**SUBJECT: NRC SPECIAL INSPECTION TEAM REVIEW AND NRC STAFF EVALUATION  
OF SOUTH TEXAS PROJECT, UNIT 1, REACTOR PRESSURE VESSEL  
BOTTOM-MOUNTED INSTRUMENTATION PENETRATION LEAKAGE  
INVESTIGATION AND REPAIR ACTIVITIES**

### NRC Staff Evaluation of South Texas Project, Unit 1, Reactor Pressure Vessel

#### Bottom-Mounted Instrumentation Nozzle Leakage Investigation and Repair Activities

# Penetration #1

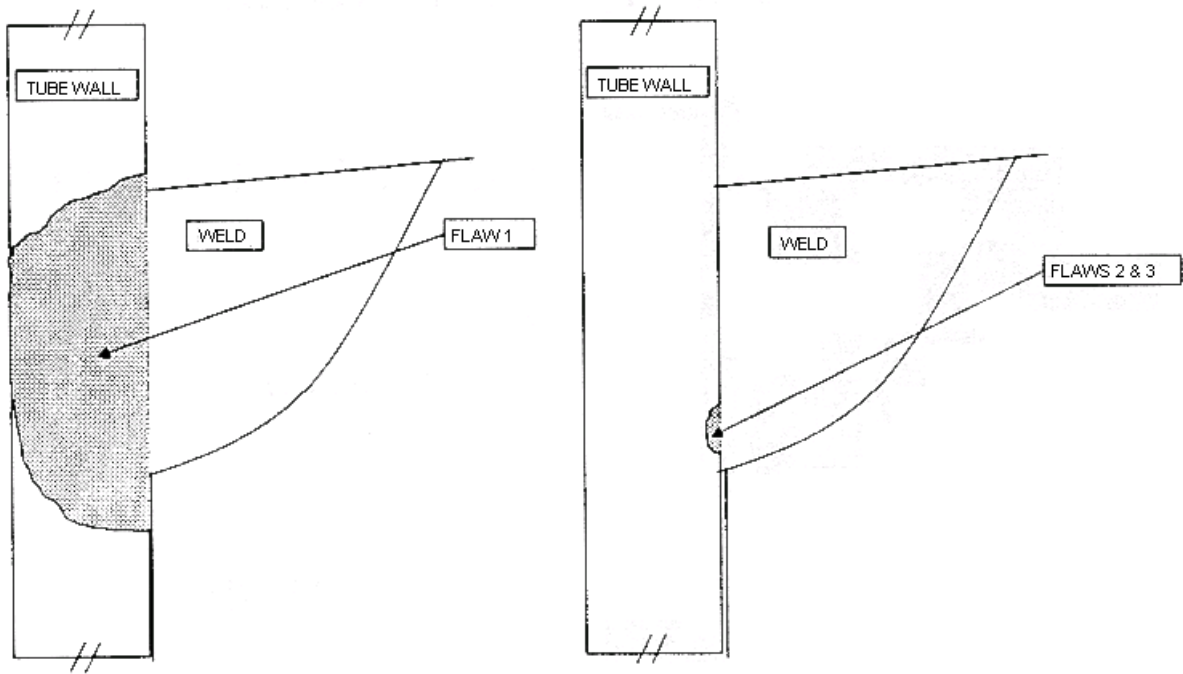
As a result of NDE activities (1) and (3) above, the licensee reported three axially-oriented crack-like indications in the penetration 1 nozzle wall and two axially-oriented crack-like indications in the penetration 46 nozzle wall. As depicted in Figure 2, one of the indications in penetration 1 was characterized as an axial crack with a length of about 1.38 inches, surface breaking on the OD of the nozzle above and below the J-groove weld, as well as surface breaking on the ID of the nozzle. The ID surface breaking nature of this flaw was confirmed by the bobbin coil ETC. The other two indications in penetration 1 were characterized as being small, embedded (i.e., non-surface breaking) cracks near the interface between the nozzle wall and the root pass of the J-groove weld. As depicted in Figure 3, one of the indications in penetration 46 was characterized as an axial crack with a length of about 0.98 inches, surface breaking on the OD of the nozzle above and below the J-groove weld. The other indication in penetration 46 was characterized as an embedded crack having an axial length of 0.95 inches. Figures 2 and 3 were submitted to the NRC as part of the licensee's presentation at a public meeting held at NRC Headquarters on June 5, 2003. However, the UT inspections conducted by the licensee were not demonstrated to be effective for the purpose of examining the subsurface volume of the J-groove weld. Therefore, the licensee's depictions of the indications as shown in Figures 2 and 3 may be incomplete with respect to subsurface cracking of the J-groove weld material. No crack-like indications were identified in any of the other 56 STP, Unit 1, BMI nozzle penetrations [Reference 2].
